## FIELD CHANGE AUTHORIZATION

CUSTOMER FLORIDA POWER CORP.	ORIGINATOR <i>J. L. Eschbach</i>	DATE <i>4-28-79</i>	CONT. NO. DOC. I.D. PCA NO. REV. NO. <i>62C-CC-704-3110</i>	<i>00</i>
SUPPLIER	P.A. NO.	PART NO., OR. TASK NO.	GROUP NO.	SEQ. NO. <i>001</i>
TITLE (MAX 30 CHARACTERS) Reactor Trip on Loss of FWP & Turbine Trip			<i>21</i>	<i>001</i>

Implement reactor trip upon loss of both main feedwater pumps or upon turbine trip.

Reactor Trip on Loss of FWP &amp; Turbine Trip

REFLECTOR TRIP ON LOSS OF FWP OR TURBINE TRIP

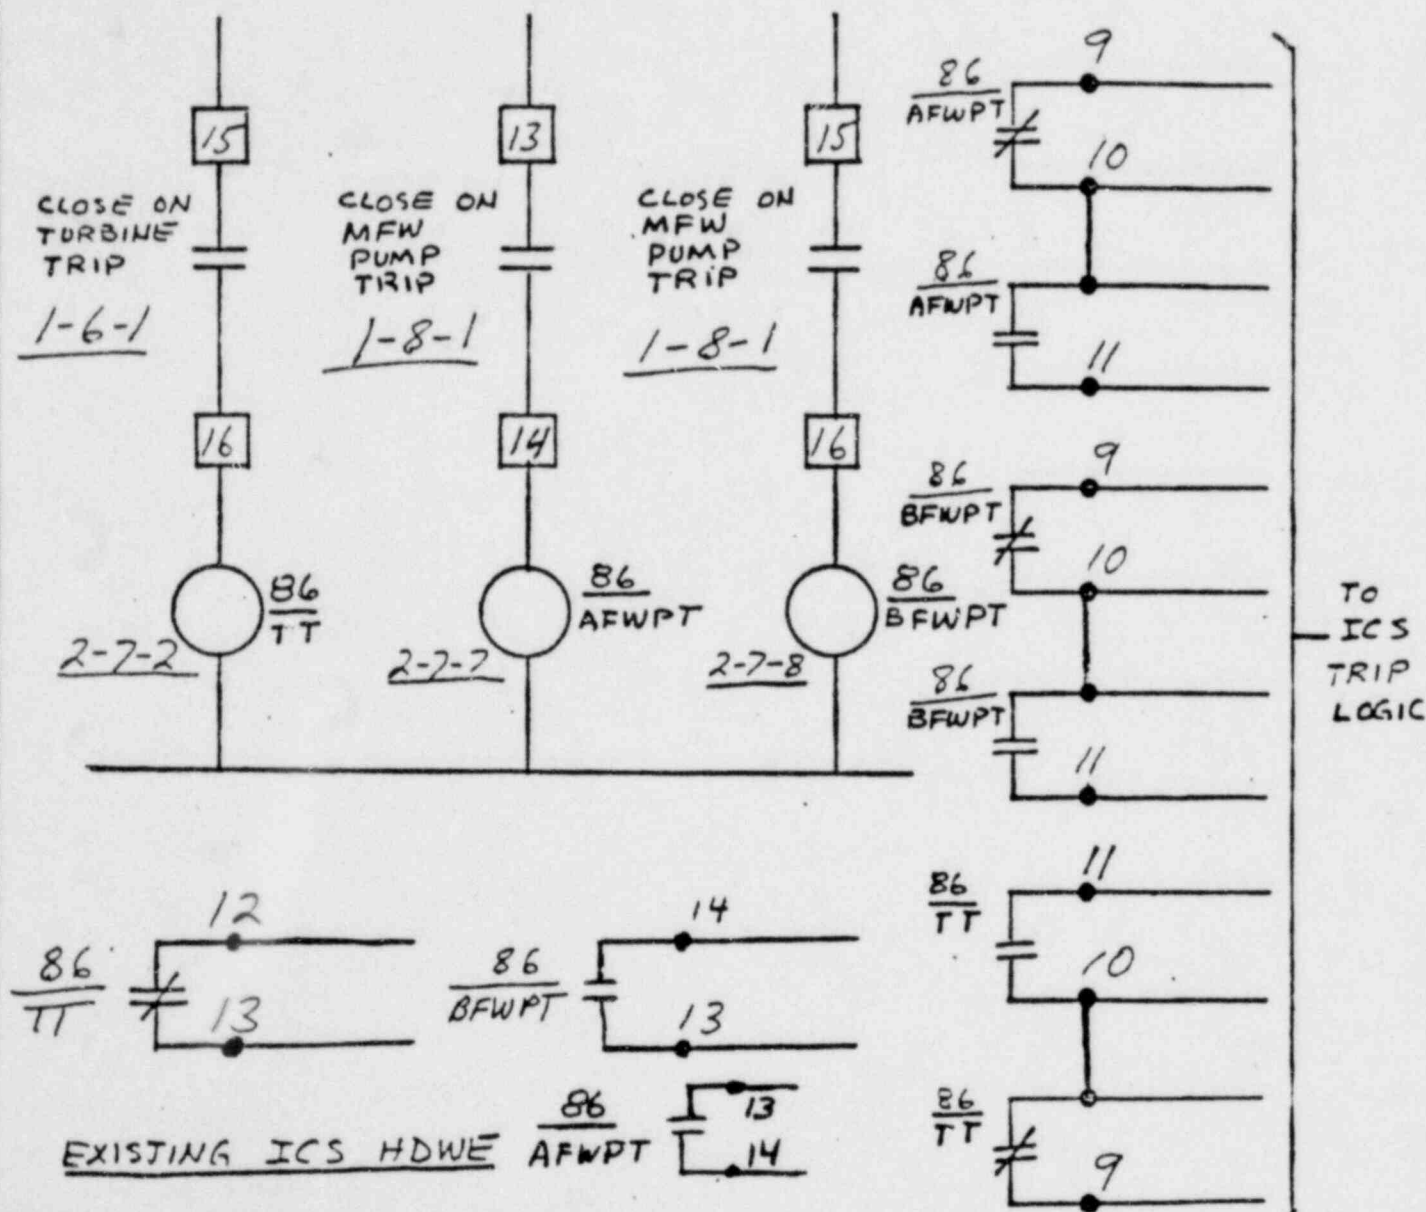
The trip of both main feedwater pumps energizes relays 86 AFWPT and 86 BFWPT. Upon loss of both main feedwater pumps relay K3 de-energizes due to the opening of parallel contacts from 86 AFWPT and 86 BFWPT.

A trip of the main turbine causes closure of the contact in series with relay 86TT. Relay 86TT energizes. This opens a contact in series with relay K3 de-energizing relay K3. K3 propagates a reactor trip as described in paragraph 3.2 above.

Assume the turbine is tripped. 86TT is energized closing a contact in series with K1. K1 may now be energized by pressing the bypass switch. K1 will seal by means of contact K1A. Contact K1C causes a control room alarm indicating a bypass state. Contact K1B is closed causing relay K3 to energize. With K3 energized control rod out motion is permitted.

Assume both main feedwater pumps are tripped. 86 AFWPT and 86 BFWPT are energized closing contacts in series with relay K2. K2 may now be energized by pressing the bypass switch. K2 will seal in by means of contact K2A. Contact K2C causes a control room alarm indicating a bypass state. Contact K2B is closed causing relay K3 to energize. With K3 energized control rod testing can be performed.

In order to allow for normal turbine shutdown, a bypass arrangement is provided. The bypass can be placed in effect only by manual action. Depressing the bypass switch energizes Relay K4 which closes contacts K4A, K4B and K4C. Contact K4A maintains the circuit to K4 when the bypass switch is released. Contact K4B maintains the circuit to relay K3 thus enabling shutdown of the turbine without reactor trip. Contact K4C provides an annunciator alarm to the control room indicating that the normal turbine shutdown bypass is implemented.

Utilizing a wire wrap tool and 22 AWG solid strand wire, connect the relays, switches and power per the attached two sketches. Power connection to be the + 24Vdc bus within the cabinet

TRIP BREAKER 3

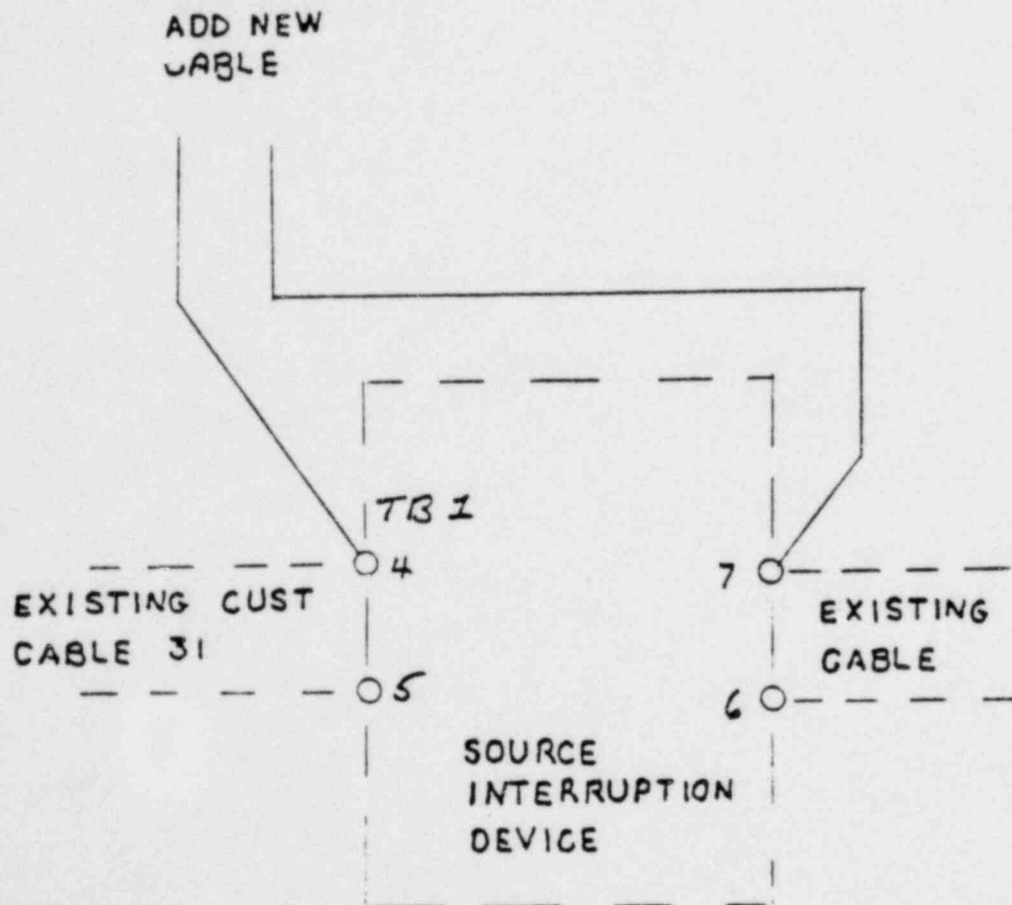
FIELD CHANGE AUTHORIZATION-CONTINUATION		<input type="checkbox"/> EXPEDITE <input checked="" type="checkbox"/> NORMAL	
REFERENCE DOCUMENT TITLE <b>REACTOR TRIP ON LOSS OF FWP OR TURB. TRIP</b>		REF DOCUMENT NO.  SHEET 1 OF 3	
DESCRIPTION OF CHANGE: <u>Installation Instructions</u> <ol style="list-style-type: none"> <li>1. Remove all power from the AC breaker cabinet before starting.</li> <li>2. Locate TBI on the source interruption device of AC breaker cabinet A and B.</li> <li>3. Add a new cable between the source interruption device A of AC breaker cabinet A and the ICS.</li> <li>4. Add a new cable between the source interruption device B of AC breaker cabinet B and the ICS.</li> <li>5. The termination of the cable on each source interruption device shall be as shown on sheets 2 and 3.</li> <li>6. The termination of the cable on the ICS shall be as shown on the sheets for Task 21 (ICS).</li> <li>7. The cables should be two conductor, 14 ga AWG.</li> </ol>
